DRB Application No.: **05DRB-00613 (P&F)**
Project Name **ALVARADO GARDENS UNIT 2**
Agent: Christopher Calott

OFFICIAL NOTICE OF DECISION

22. **Project # 1003694**
05DRB-00613 Minor-Prelim&Final Plat Approval
05DRB-00614 Minor-Subd Design (DPM) Variance

**CITY OF ALBUQUERQUE
PLANNING DEPARTMENT
April 20, 2005
DRB Comments**

SKETCH PLAT SUBDIVISION PLAN FOR: LOT BB, ALVARADO GARDENS, UNIT 2

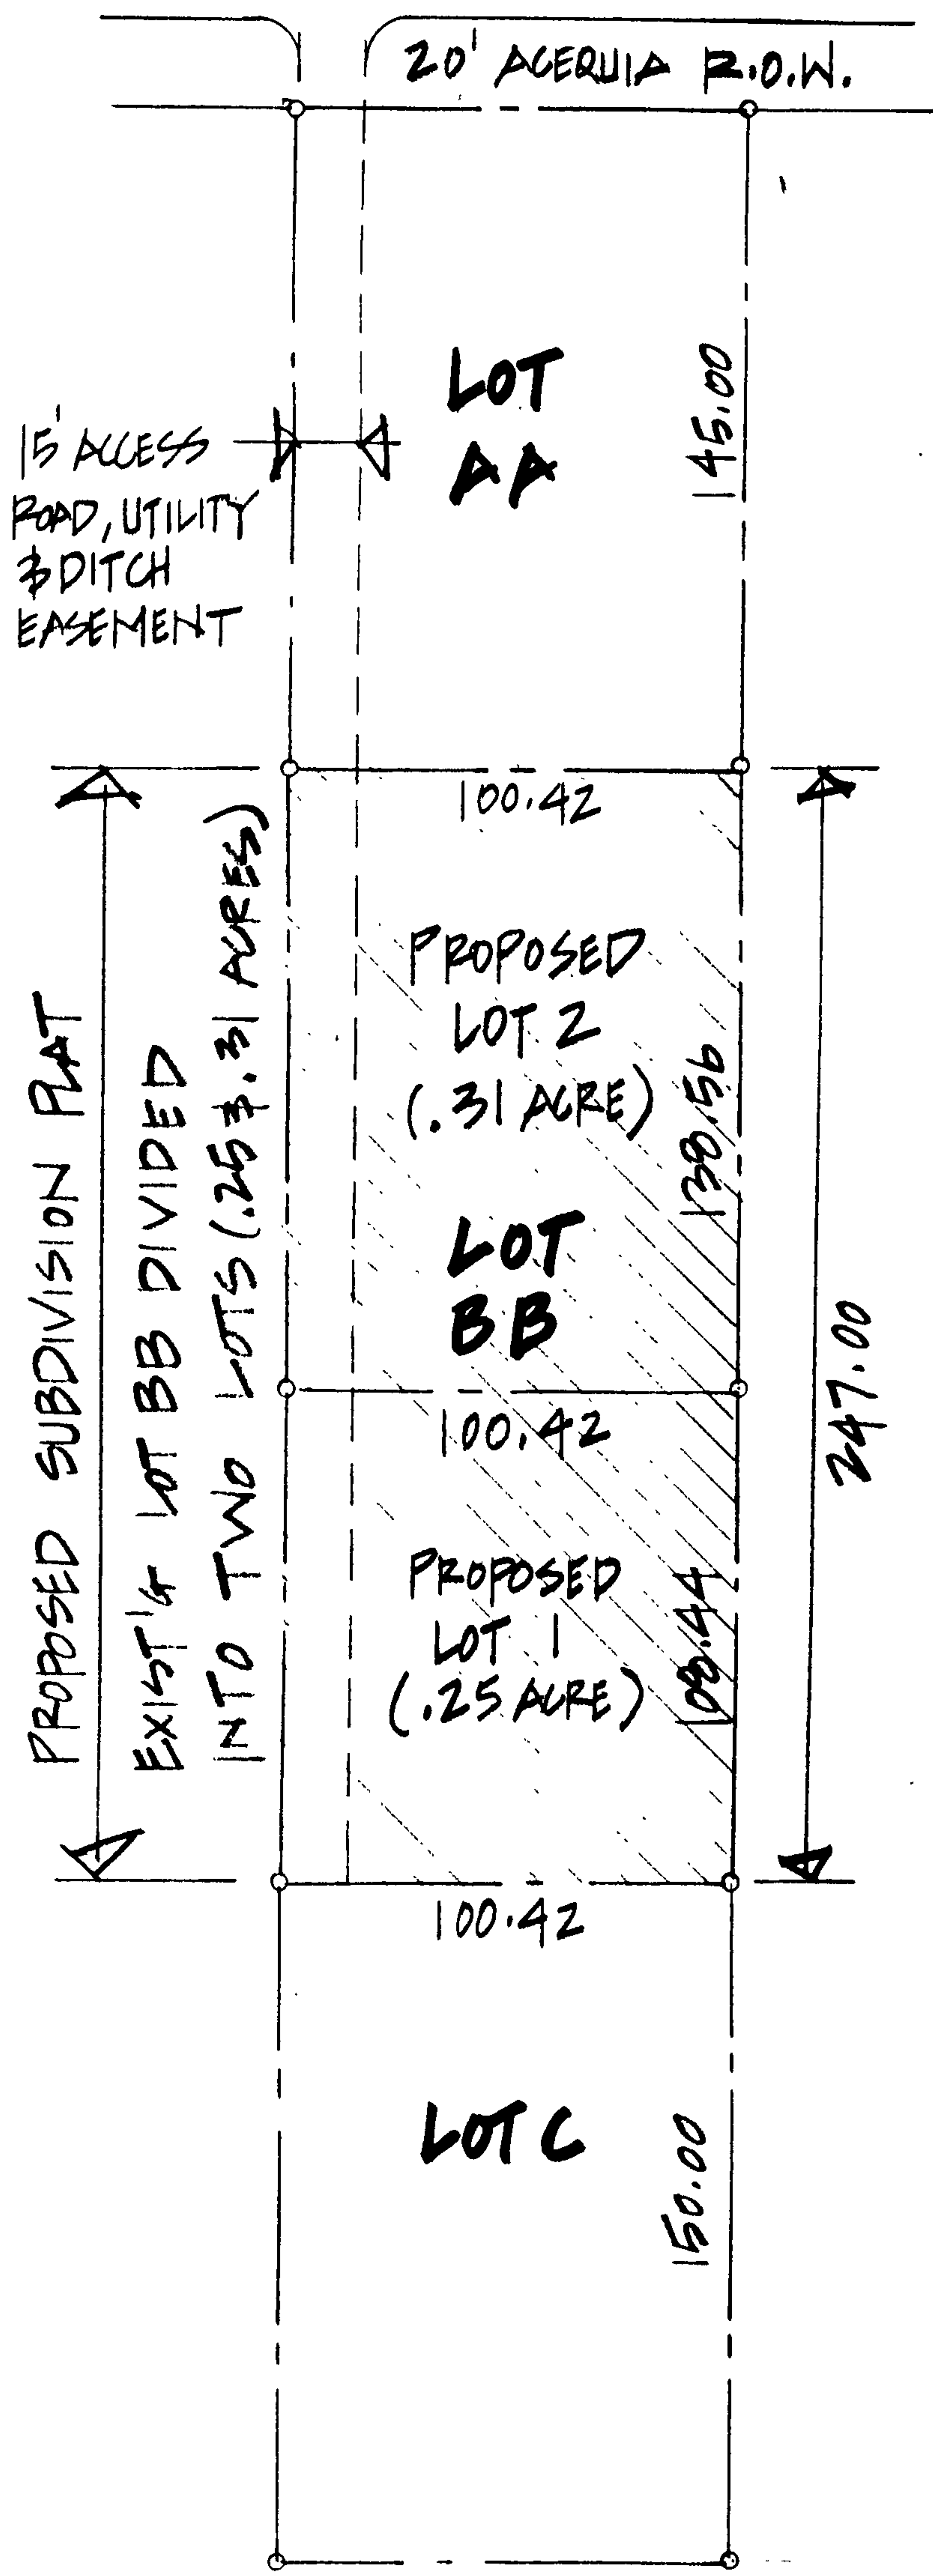
The proposed new lots meet the minimum lot size requirements for RA2 zoning.

The only comment I have is...we are the Development Review Board, rather than the Design Review Board.
